## **PLANNING COMMITTEE**

- (e) LA04/2023/2748/A - 1 Digital Advertisement Display - 12-13 Shaftesbury Square (Pages 3 - 14)

## Development Management Officer Report Committee Application

Summary	
<b>Application Ref:</b> LA04/2023/2748/A	<b>Committee Meeting Date:</b> 14 <sup>th</sup> May 2024
<b>Proposal:</b> 1 Digital Advertisement Display	<b>Location:</b> 12-13 Shaftesbury Square, Belfast, BT2 7DB
<b>Referral Route:</b> Paragraph 3.8.1 of the Scheme of Delegation – request to be reported to Planning Committee by Elected Member.	
<b>Recommendation:</b>	Refusal.
<b>Applicant Name and Address:</b> Michael Fairfowl 5b Willowbank Rd, Milbrook Larne BT40 2SF	<b>Agent Name and Address:</b> Enda McKenna Unit A3 Harbour Court, 5 Heron Road Belfast BT3 9HB
<p><b>Executive Summary</b></p> <p>This application seeks advertisement consent for a digital advertisement located at Nos.12-13 Shaftesbury Square.</p> <p>The key issues are:</p> <ul style="list-style-type: none"> <li>• Impact on amenity</li> <li>• Impact on the setting of listed buildings</li> <li>• Impact on public safety.</li> </ul> <p>The application has been referred to the Committee following a request from Councillor Magee.</

## Proposed Plans

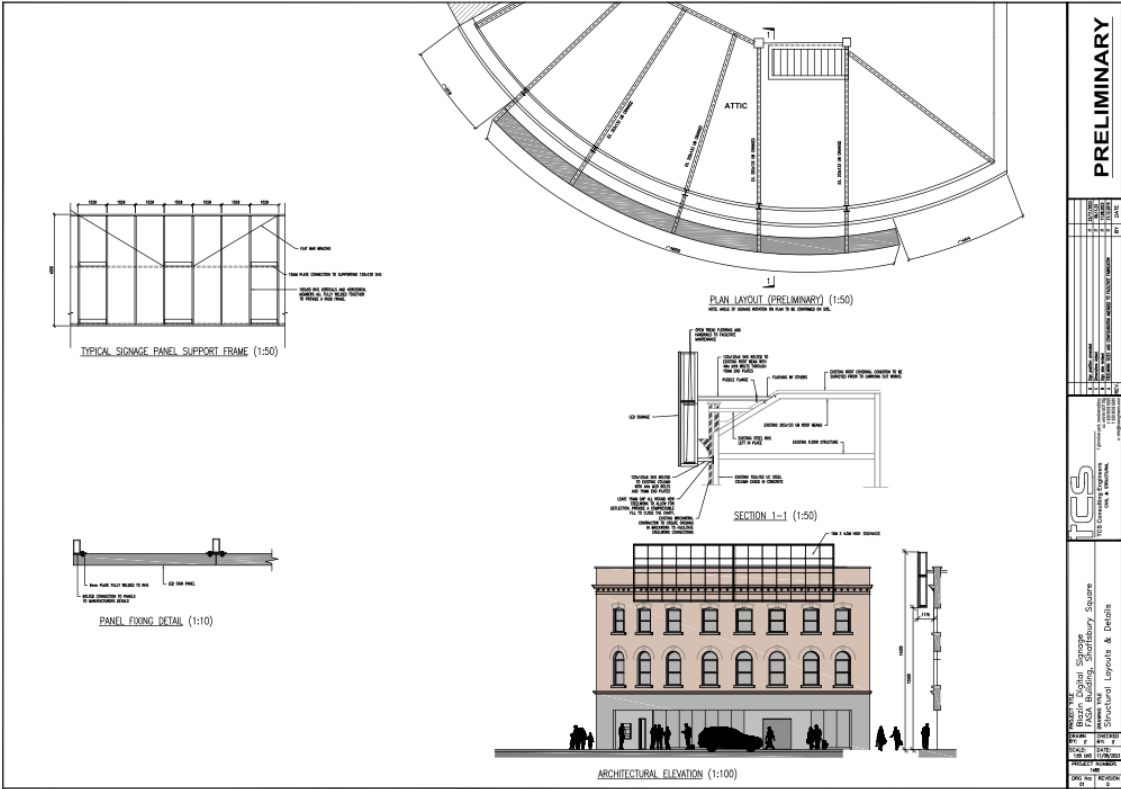
6.4.6	<p>The initial drawings submitted with the application proposed an LED sign which measured 20m (length) x 5m (height). During the processing of the application, officers Dfl Roads and HED met with the applicant to discuss concerns and amended drawings were received seeking to address issues raised in respect of amenity, road safety and impact on the adjacent listed building. The most recent amendment shows a reduction in size to 16m (length) x 4m (height).</p>

6.4.8	<p>The proposed digital sign would project above the parapet by approximately 1.8m and would obscure key architectural features such as the mutilated cornice, in contravention of the SPG. Whilst it is acknowledged that the existing sign obscures some key features, the proposed sign would be 9.2m longer than the existing sign and 0.2m higher and would be located approximately 1.3m from the edge of the building on both sides. As a result, a substantial part of the building's key features at parapet level would be obscured. The sign itself is approximately 3m in depth and would be highly visually prominent when viewed from surrounding streets including Botanic Avenue and Donegall Pass. It is considered that the sign would be visually prominent in the streetscape with short and medium range views available including views on approach from Great Victoria Street. Given the significant size of the sign and proposed location at high level along with the digital format, the proposal would be unacceptably prominent and harmful in the street scene and of a scale which would adversely impact the character and appearance of the area. The proposed sign would also be an overly dominant feature on the host building and would be significantly harmful to the visual amenity of the area.</p>

6.5.4	<p>HED has objected to the application on the grounds that the proposal would negatively impact on the setting of the Grade B2 Listed building at 2-6 Bradbury Place. They advise that '<i>The listed building of 2-6 Bradbury Place is positioned on the junction of Shaftesbury Square, Donegall Road and Bradbury Place. A key feature of the building is how it has been designed to be read on the approach from the Dublin Road as the listed building 'addresses' this approach - as expressed by the curved façade design towards the junction. We add that 1 Bradbury Place, Malone Lower (HB26 29 031), although not listed, has also been designed to 'address' the junction of Shaftesbury Square, Donegall Road and Bradbury Place. Again, notable due to the curved façade at the junction.</i>'</p> <p><i>'HED acknowledge the existing illuminated signage on the application site, albeit significantly smaller in size than the current proposal. The proposed 20m x 5m, Digital Advertisement Display would form a continuous band across the full of the application building's façade. Due to the increased size and nature of the proposed moving/kinetic electronic signage screen, we consider the installation would have a detrimental impact on the setting of the listed building, due to its scale, form, height, alignment and would</i></p>

6.6.4	<p>DFI Roads advises that <i>‘the proposed digital display is significantly larger than the current display and would therefore intensify the risk of driver distraction’</i>. They go on to say that <i>‘this proposal conflicts with’</i> the SPG, Para. 4.6.2 (b) <i>in that it would, if permitted, prejudice the safety and convenience of road users. Since the erection of this proposal,</i></p>
